DESCRIPTIVE REPORT

Sheet No. B-36

~~PORT~~ GASTINEAU CHANNEL

REVIEW OF TOPOGRAPHIC SURVEY No. 6519 (1936) Field No. B-36

Revision Survey - 1:1250 scale
Standard Oil Co. Wharf, Juneau,
Alaska, Sept. - 1937.

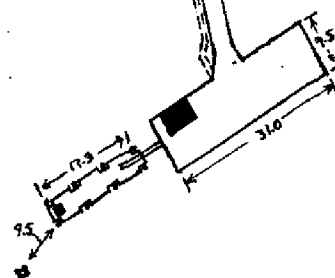
The revision on this survey was made on a photostat and accompanied by scale drawings of 1:1250. It was transferred to the original sheet in red and actual measurements were used as given on the detail drawings.
